STATEMENT OF CASE

Land at Bird in Eye Farm, South of Bird in Eye Hill, Framfield, TN22 5HA

APP/C1435/W/22/3307820

TECHNICAL NOTE 1 – HIGHWAYS AND TRANSPORT CONSIDERATIONS

Figure 3.1: Approximate Capacity of Priority Junctions

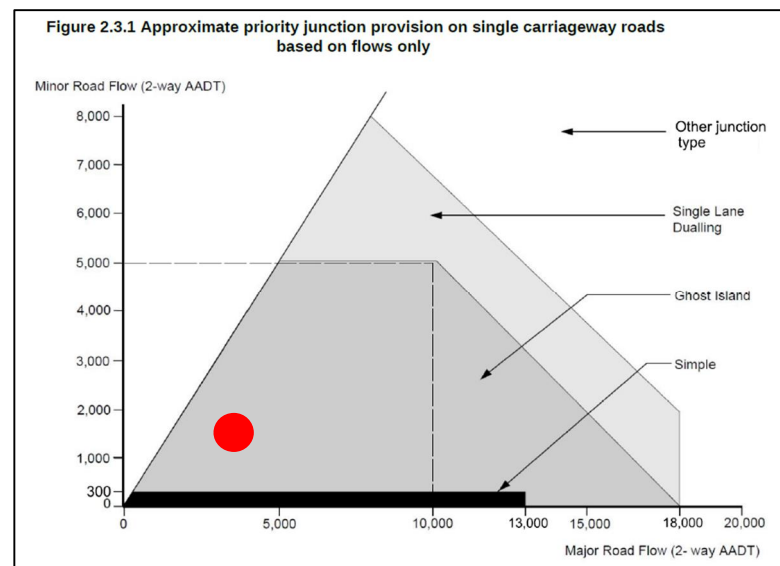
- 3.7 The daily traffic volumes contained in the TA (Table 1) and the likely number of trips generated by the proposed development identified in the TA (Table 7) means that the traffic volumes associated with the proposed access junction lie well outside the typical operational capacity of a simple priority junction as shown by the red dot in **Figure 3.1**.
- 3.8 **Figure 3.1** shows that a ghost island priority junction, i.e. with a separate right turning lane to avoid vehicles waiting to turn right into the site obstructing eastbound through traffic, is required in traffic flow terms and thus supports ESCC's position that such a junction should be provided to access the site.

Figure 3.2: Proposed Traffic Island west of Site Access Junction

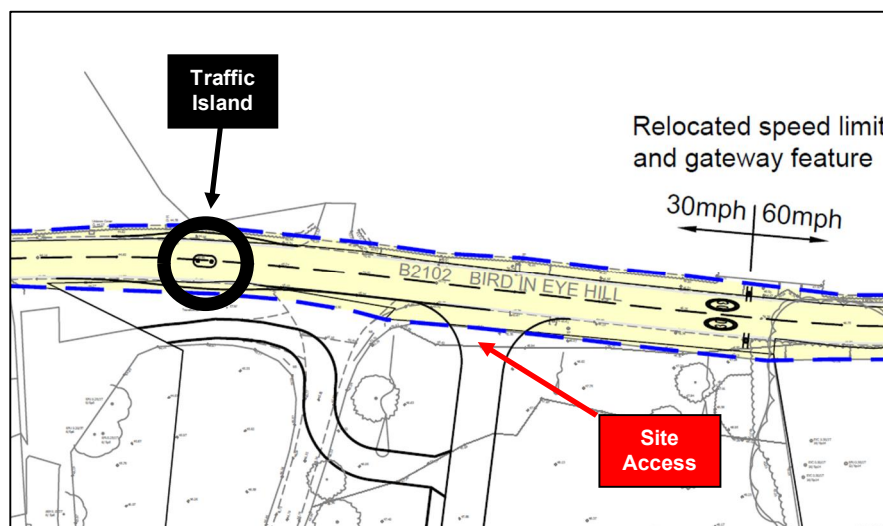
- 3.21 The provision of a traffic island in this location appears to be a contrived measure added simply to enable the visibility to be measured in a way that means that the splay avoids third party land if vehicle speeds remain at present levels and a 30mph speed limit is not introduced via a TRO. **Figure 3.2** below provides an extract of the site access drawing and shows the location of the proposed traffic island and the site access junction.

- The provision of a traffic island to the west of the proposed site access junction appears to be a contrived measure added simply to enable the visibility to be measured in a way that means that the splay avoids third party land if vehicle speeds remain at present levels and a 30mph speed limit is not introduced via a TRO.

Figure 3.3: Visibility Splay and Number 18 Bird in Eye Hill

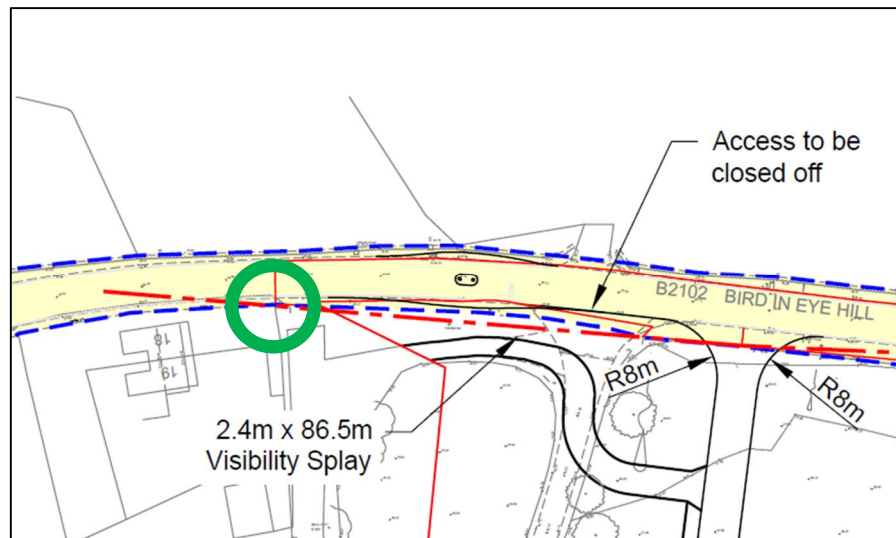
- 3.22 It is important to note that the visibility spay (sight line) to the west just manages to avoid the northeast corner of the garden of number 18 (Bird in Eye Hill) as shown overleaf in **Figure 3.3** by the green circle, which just so happens to be outside the red line/site area. If the visibility splay had been drawn to the nearside kerb, then part of the garden of number 18 would be required to achieve the visibility splay based on the surveyed speeds on this part of the B2102.
- 3.23 Given there are no footways in the vicinity of the proposed traffic island and as there are proposed roundels advising of the 30mph speed either side of the island, it is unclear precisely what function this proposed feature will have other than to enable the visibility splay to be measured in a way that suits the applicant.

Figure 3.4: Visibility Splay and Number 18 Bird in Eye Hill

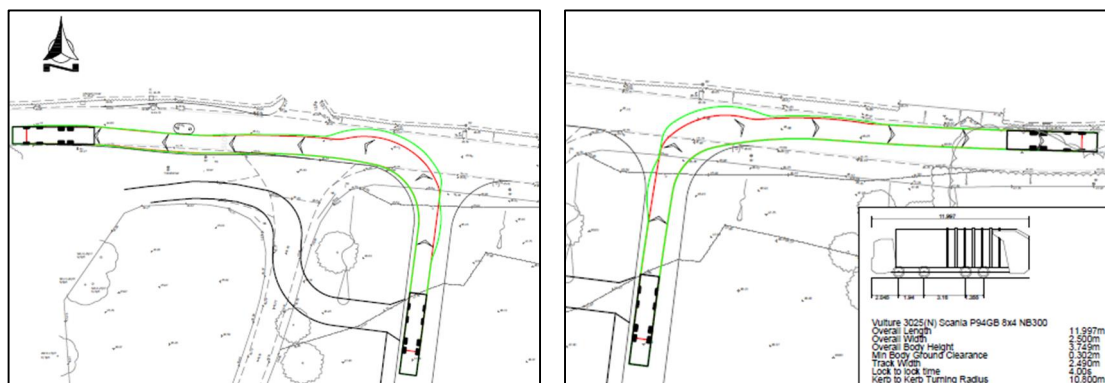
- 3.24 The TA contains swept path analysis showing a refuse vehicle entering and exiting the site via the proposed access junction.
- 3.25 **Figure 3.4** below provides an extract of the exit manoeuvres and shows that the left and right turns out of the site are problematic in that they involve the vehicle encroaching across all of the B2102.

- 3.26 Whilst the TA states in section 5.14 that such vehicles can 'conveniently and safely' leave the site in a forward gear, this is questionable based upon the images shown in **Figure 3.4**.

Figure 3.5: Location of Problems identified in RSA at Vehicular Access

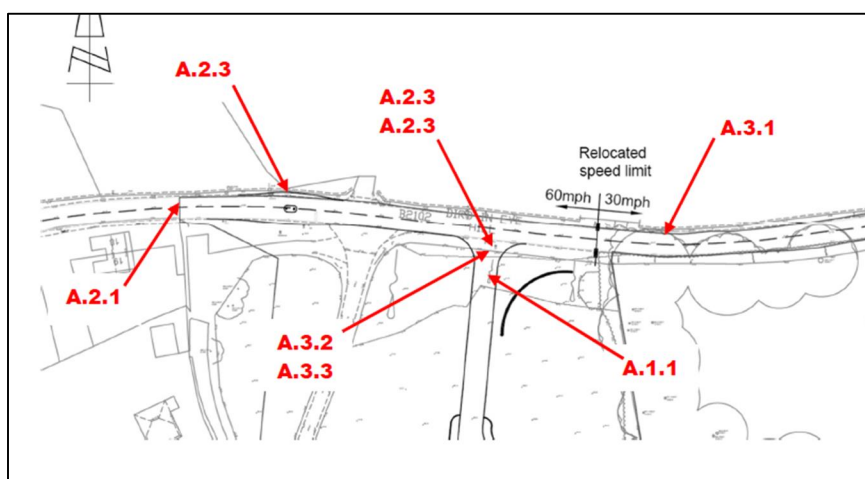
- 3.32 One of these problems (A.2.1) relates to the traffic island discussed above in section 3.21, which enables the visibility to be measured in a way that avoids third party land. An alternative approach to this issue would be to locate the site access junction in a position where it could provide the required visibility (for the surveyed speeds) rather than introduce traffic islands where they do not appear to be needed for any other reasons.

- 3.33 Problem A.3.1 relates to forward visibility between westbound vehicles and vehicles waiting to turn right into the site. The RSA identifies that vegetation within the verge north of the carriageway restricts visibility and, as such, drivers will not have enough warning of right turning vehicles into and from the site. The designer's response refers to the proposed 30mph speed limit (which will need a TRO) but otherwise offers no solution to this issue.

- 3.34 Problem A.3.3 relates to the swept path analysis mentioned in section 3.25 above and the fact that larger vehicles are likely to encroach into opposing lanes (the RSA was written without the benefit of seeing the swept path analysis included in the TA as

Appendix 14). The designer's response states that the swept path analysis shows that these manoeuvres are adequate but this is not accepted as stated in section 3.26 above.

Figure 4.1: Termination of Shared Footway/Cycleway

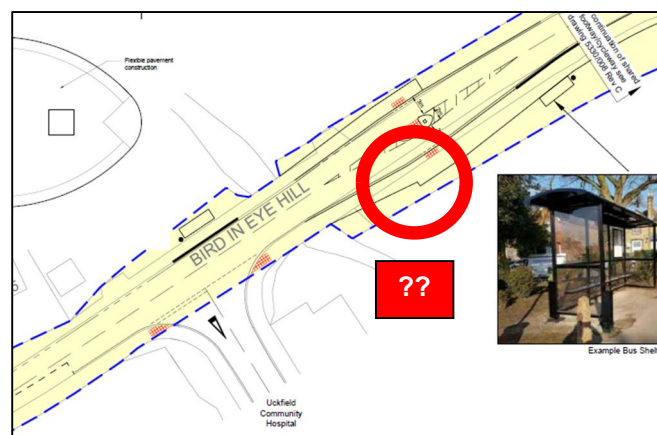
- 4.3 The section of footway along the southern side of Bird in Eye Hill between the pedestrian cycle access and bus stops will be widened to 3m and designated as a shared footway/cycleway. However, it is unclear what happens to cyclists when the shared footway/cycleway terminates at the westbound bus stop just before the access to Uckfield Community Hospital as shown below in **Figure 4.1**.

Figure 5.3: CrashMap Data from the TA

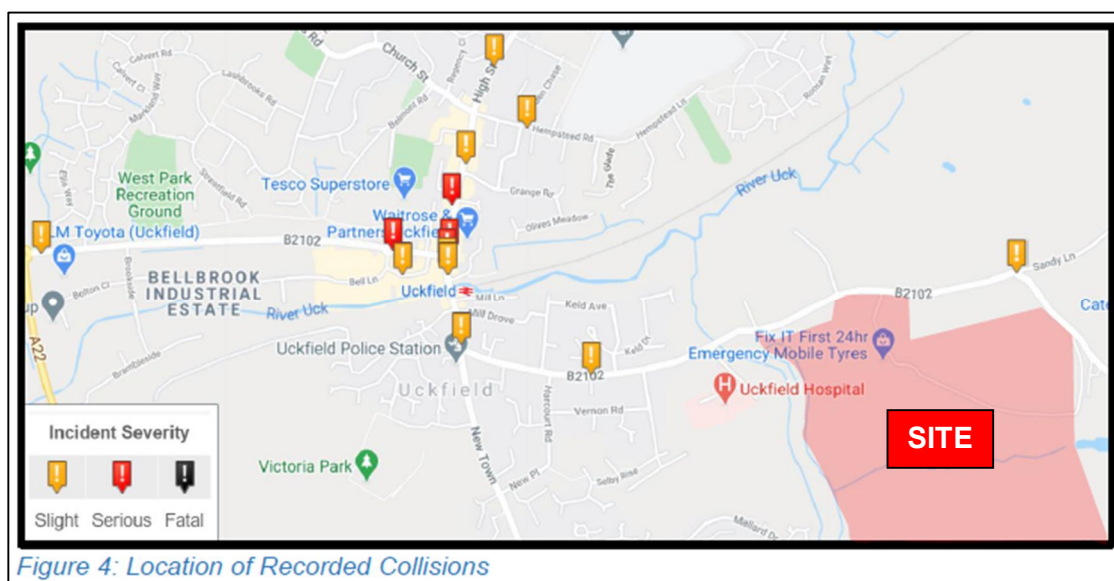
- 5.24 This shows that there were no accidents close to the proposed site access (and the existing farm access) and just one accident at the junction of Bird in Eye Hill (the B2102) and Sandy Lane to the east of the site.
- 5.25 However, an interrogation of the CrashMap website identifies that two further accidents occurred in the vicinity of the site as shown overleaf in **Figure 5.4**. The CrashMap reports for these accidents are contained as **Appendix A** of this Technical Note.

Figure 5.4: Additional CrashMap Data

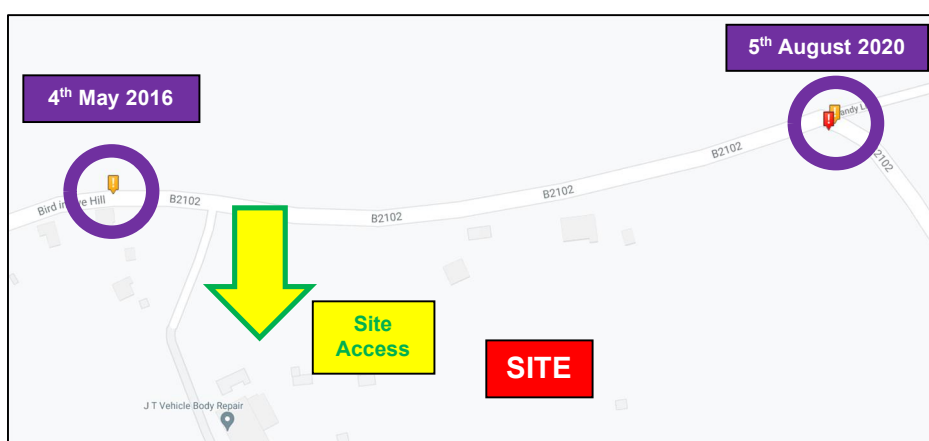
- 5.26 The accident to the west of the site access occurred in 2016 and so would have been identified in the TA if a 5-year period had been selected as is usual. This accident involved a van and a cyclist and resulted in slight injuries being sustained by the cyclist. The location of the accident close to the proposed site access, where forward visibility has been raised as an issue in the RSA, adds to the concerns over the safety of the proposed access junction.

- 5.27 The other additional accident occurred at the junction of Bird in Eye Hill and Sandy Lane to the east of the site. Whilst this accident is likely to have been added to the CrashMap database since the TA was completed, it is important to note its occurrence. This accident involved two cars and resulted in slight and serious injuries being sustained by the occupants of the two cars.

- 5.28 The emergence of these additional accidents suggests that the stretch of the B2102 in the vicinity of the proposed site access junction is not as safe as concluded in the TA and this will be exacerbated by the increase in traffic volumes associated with the proposed development and the provision of a substandard access junction.

Figure 6.1: Footway Widths from Manual for Streets

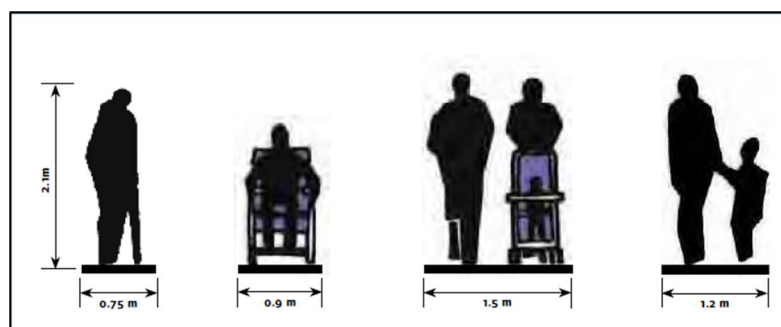
- 6.2 **Figure 6.1** shows that the parts of Framfield Road with a footway width below 1.5m will not allow a buggy and pedestrian to safely pass and so will not encourage future residents to walk to local facilities. Whilst the TA states that pedestrians can cross Framfield Road at this point (and proposes to provide tactile crossing at this location) this is not ideal and will do little to maximise sustainable travel to/from the site.

- 6.3 Such width restrictions will affect the perceived quality of the walking route between the town centre and the site and influence the propensity of future residents to undertake journeys on foot. Moreover, a pedestrian route that is attractive and direct, as well as being safe and secure, will generate higher numbers of pedestrians than one that is narrow, involves crossing movements and is generally of poor quality as is the case along parts of Framfield Road.

Figure 2.1: Visibility Splay to the West

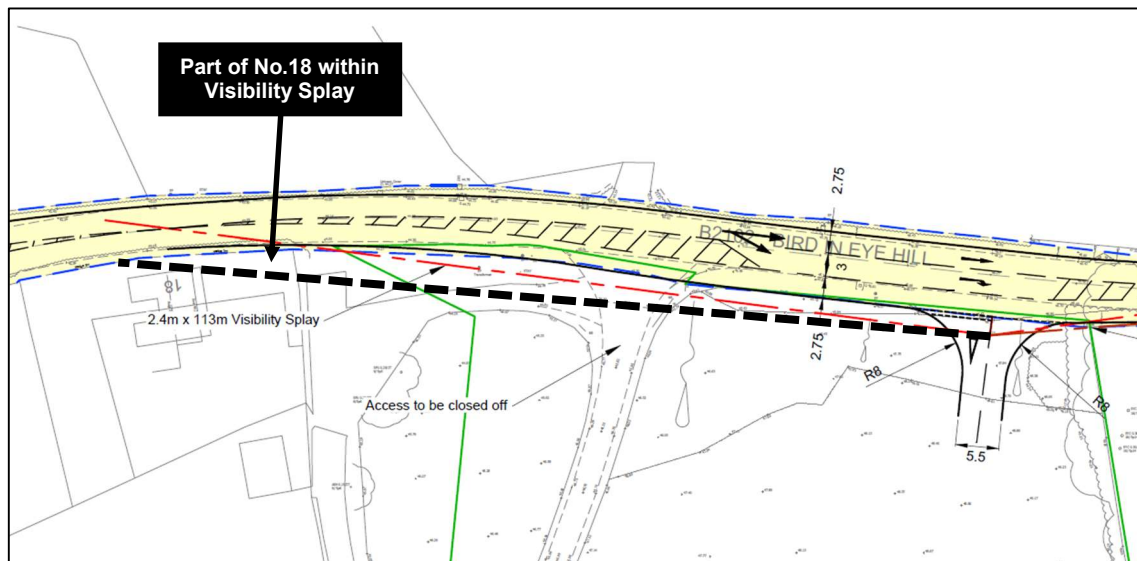
- 2.8 The provision of a traffic island in this location will not prevent overtaking manoeuvres and so the visibility splay to the west should be measured to the nearside kerb. If this is the case, then the visibility splay will pass through the northeast corner of the garden of number 18 (Bird in Eye Hill) as shown overleaf in **Figure 2.1**.

- 2.9 Given that there are no footways in the vicinity of the proposed traffic island, it is unclear precisely what function this proposed feature will have other than to enable the visibility splay to be measured in a way that avoids third party land.

- 2.11 Given that the introduction of a 30mph speed limit is by no means guaranteed, the level of visibility afforded at the site access junction must accord with actual speeds on the B2102 and be measured in the correct manner.
- 2.12 Clearly this is not the case at present so it is maintained that the site access will not be safe due to a lack of visibility to the west.
